Preliminary Consultation
MONTGOMERY COUNTY HISTORIC PRESERVATION COMMISSION
STAFF REPORT

Address:	7306 Maple Ave., Takoma Park	Meeting Date:	3/27/19
Resource:	Contributing Resource Takoma Park Historic District	Report Date:	3/20/19
Applicant:	Amit and Anjali Patel	Public Notice:	3/13/19
Review:	Preliminary Consultation	Staff:	Dan Bruechert
Proposal:	Partial Demolition and Building Addition

PROPOSED
ROOF PLAN

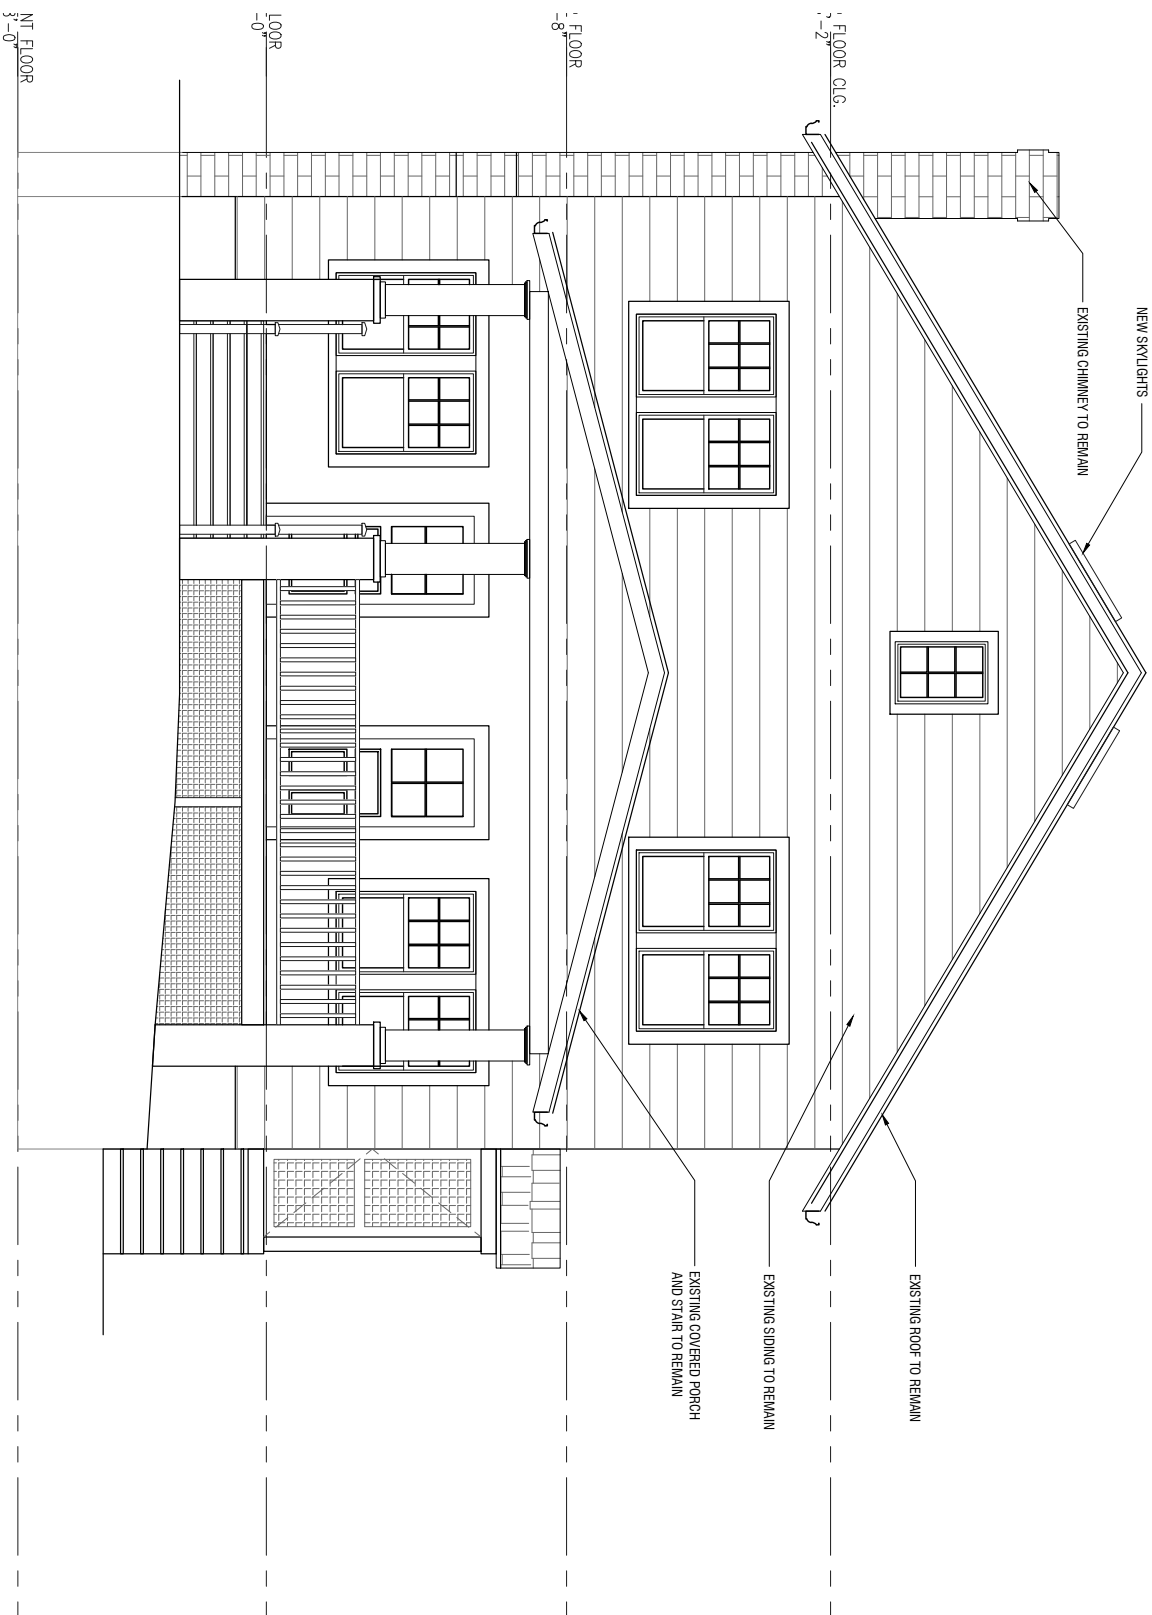
The applicant proposes to install two new skylights, one on the north slope and one on the south slope of the principal gable. Staff finds that due to the height and pitch of the roof, these features will not be highly visible from the right-of-way and does not constitute a substantial alteration under 24A-8(b)(1) and Staff would recommend approval at the HAWP stage.

PROPOSED NORTH
ELEVATION

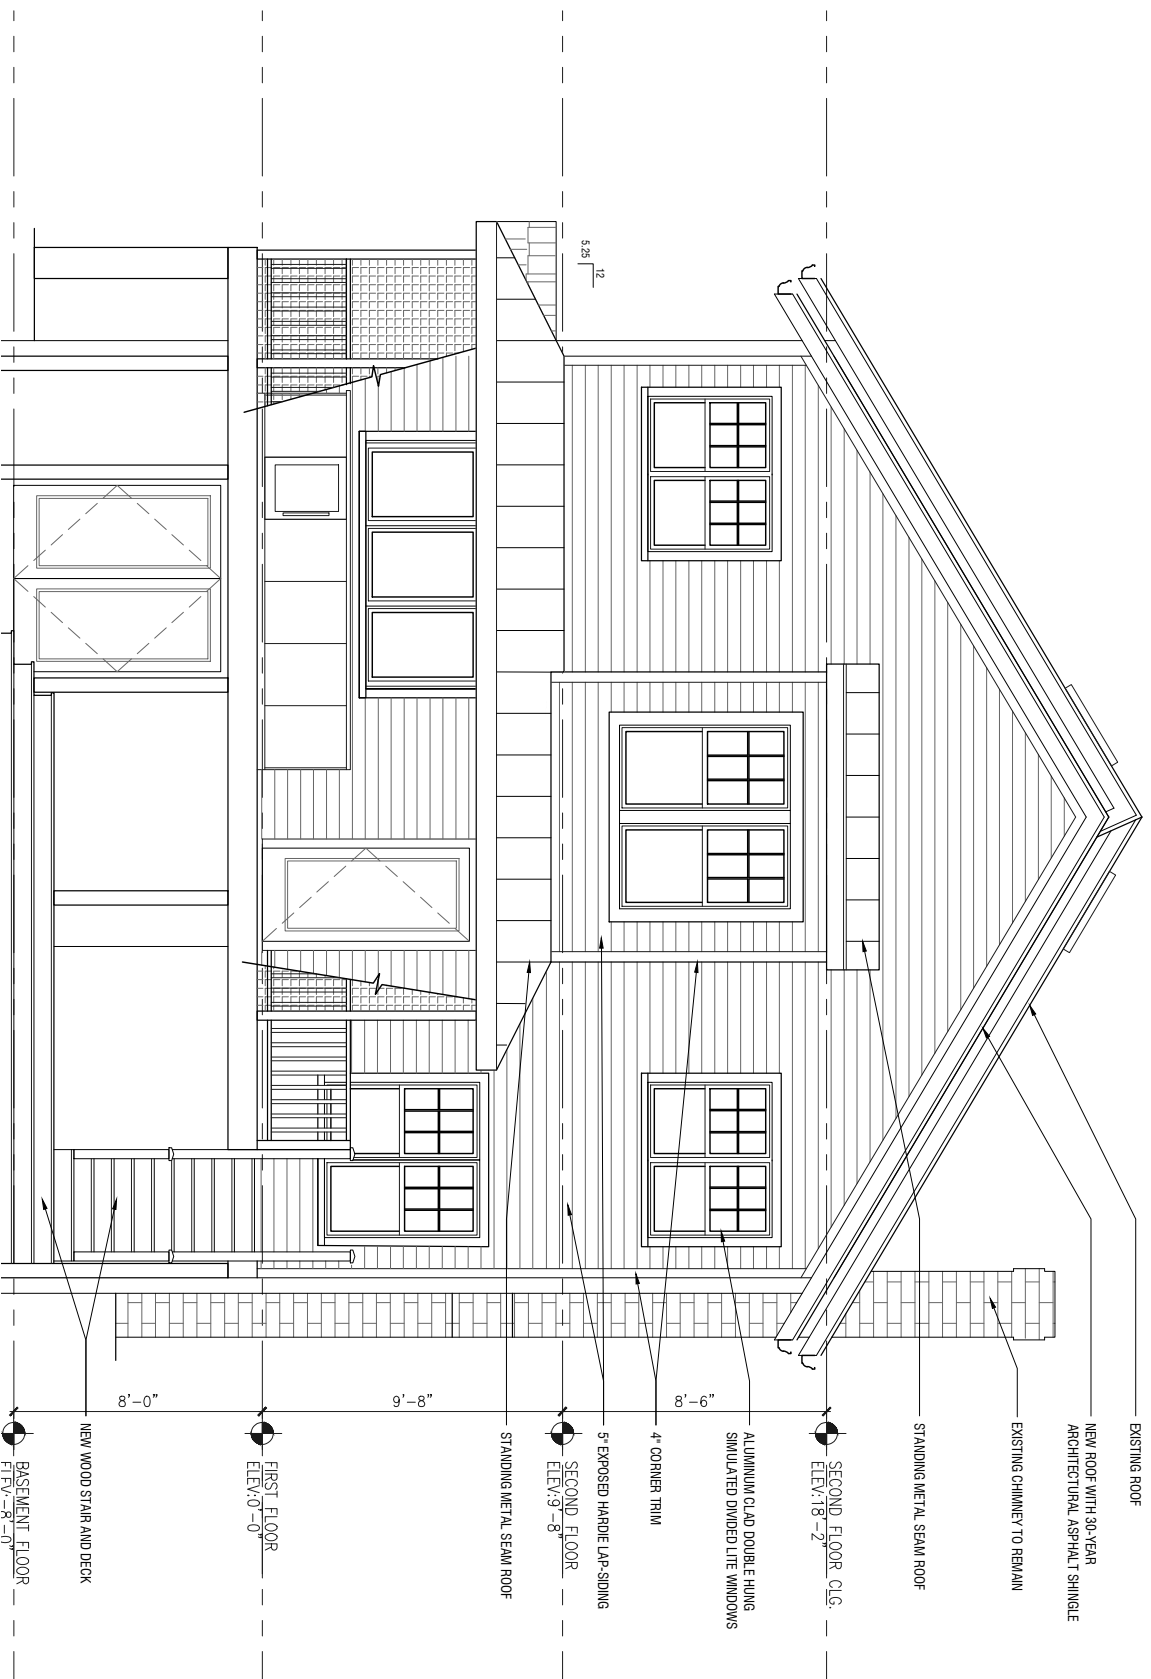
Currently, the side entrance on the north elevation has a simple gable roof covering the side door. The applicant proposes removing this roof and reconstructing it with a side facing gable of approximately the same dimensions and extending the roof to the rear, creating a side/rear wrap around porch. The roof will be covered in standing seam metal, matching the roof proposed at the rear, discussed below. This will not change the appearance of the house from the front but will be visible from an oblique angle. This visibility is increased due to the double-width driveway to the right.

Staff finds that the extending this roofline would change the massing and balance of the design and would be highly visible from the public right-of-way. Staff recommends this feature be eliminated from the design or altered to lessen its visual impact.

**PROPOSED REAR
ELEVATION (WEST)**

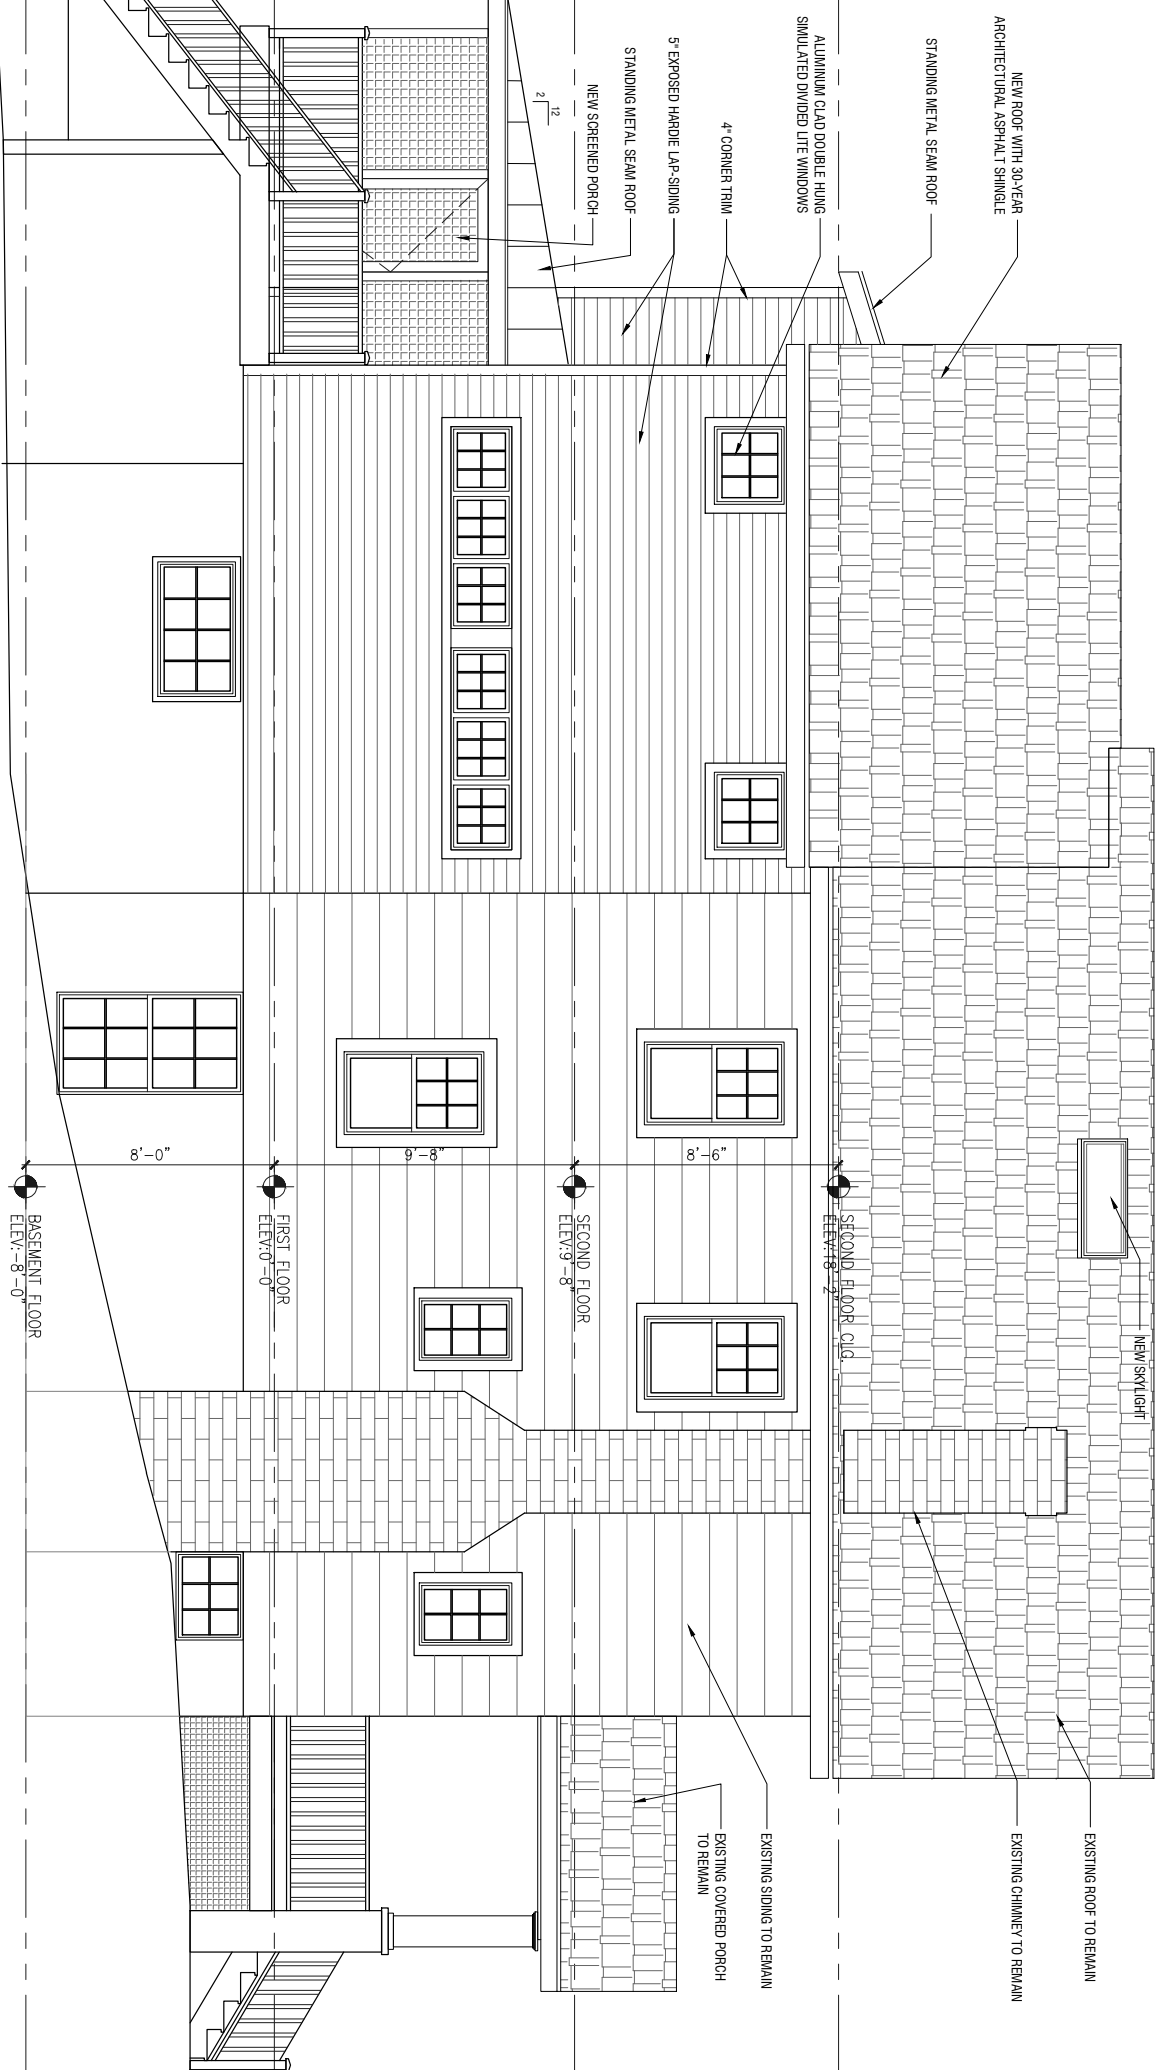
The rear addition will have a large, rear facing gable and is based on the shape of the historic house. Exact dimensions were not included in the drawings, but it appears that the addition will be inset by approximately 6" (six inches) from the historic wall plans and the roof ridge will be approximately 1' (one foot) lower than the historic roof ridge and will match the roof slope. The addition will be clad in fiber cement in a 5" (five-inch) reveal and will have an architectural shingle roof. The proposed windows will be six-over-one aluminum clad wood windows on the north and west elevation and will have six-lite casement windows on the south elevation. The north elevation will have two pairs of sash windows on the second floor. The south elevation will have a row of six-lite casement windows on the first floor and two six-lite casement windows on the second floor (the drawings label these windows incorrectly as sash windows. The rear elevation has four pairs of six-over-one sash windows, including one set in and second floor central bay. The applicant also proposes to install a triple set of single-lite casement windows on the first floor in the northwest corner.

The applicant proposes constructing a screened-in porch to the rear with a standing seam metal hipped roof above. The framing, stairs, and railing of the porch will all be wood. The roofline of the porch will connect to the extension of the north porch, discussed above.

Staff additionally finds that the rear porch should not project beyond the wall plane of the addition. This projection alters the balance and massing of the design and will be visible from the right-of-way. Due to the depth of the lot, Staff would be supportive of a deeper porch that did not project quite as wide.
